APPLICATION NO.	FILING DATE	FIRST NAMED INVENTOR	ATTORNEY DOCKET NO.	CONFIRMATION NO.
10/553,832	10/20/2005	Mario Giorgio Prussiani	2502-1089	6302
466 YOUNG & TH	7590 10/01/2007 HOMPSON	EXAMINER		
745 SOUTH 23RD STREET			SCRUGGS, ROBERT J	
2ND FLOOR ARLINGTON, VA 22202		,	ART UNIT	PAPER NUMBER
			3723	
			· · · · · · · · · · · · · · · · · · ·	
			MAIL DATE	DELIVERY MODE
			10/01/2007	PAPER

DETAILED ACTION

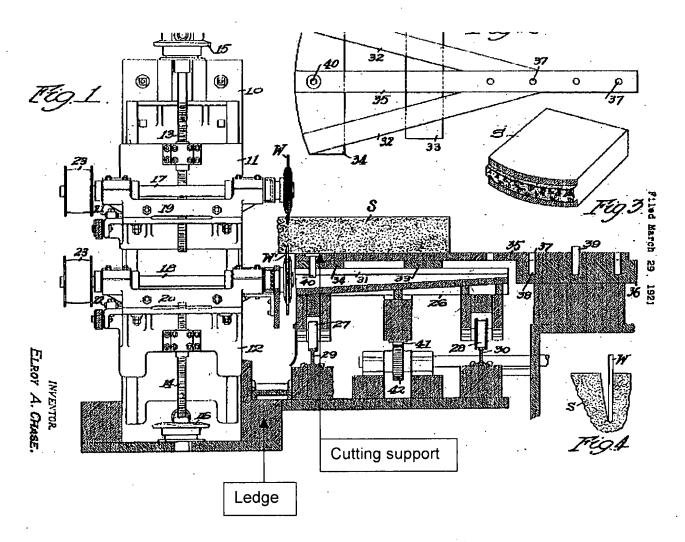
In reference to claims 28 and 40, Bando discloses the claimed previously mentioned above, but lacks, a cutting disc disposed to a side of the cutting support. However, Chase discloses a cutting disc (W) disposed to a side of the cutting support (See figure below). It would have been obvious to one of ordinary skill in the art at the time the invention was made to modify the device, of Bando, with lower cutting disc, in view of

In reference to claims 31 and 43, Chase also discloses that the vertical guides are fixed to a ledge projecting from said support (see figure above).

In reference to claims 28 and 40, Christian discloses the claimed previously mentioned above, but lacks, a cutting disc disposed to a side of the cutting support. However, Chase discloses a cutting disc (W') disposed to a side of the cutting support (See figure above). It would have been obvious to one of ordinary skill in the art at the time the invention was made to modify the device, of Bando, with lower cutting disc, in view of Chase, in order to cut different sections of a workpiece simultaneously thereby increasing productivity and efficiency.

to a ledge projecting from said support (see figure above).
